Loop Beach and Bathhouse

Town of Barnstable ADA Transition Plan

October 2021

Institute for Human Centered Design

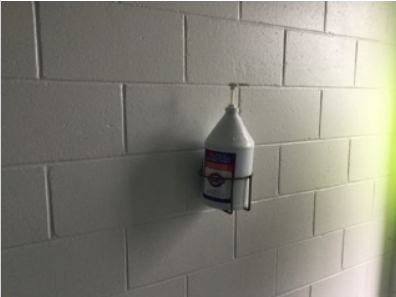
8	Women's Toilet Room	1		Doors, Doorways, & Gates			Clear width at door < 32" Maneuvering clearance(s) not provided	31" 9"	Widen the door so that there is 32" min. clear width. Provide an automatic door opener.	1	6426	\$6426

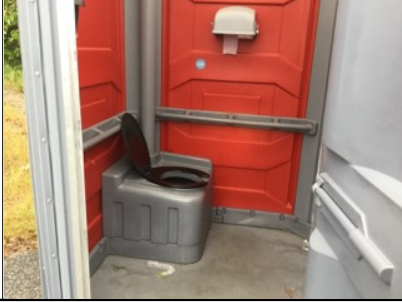
13	Women's Toilet Room	Ext.		Signage	Designation		Raised characters not provided on sign Braille not provided on sign	- -	Provide text with raised characters duplicated in braille on sign.	1	232	\$232
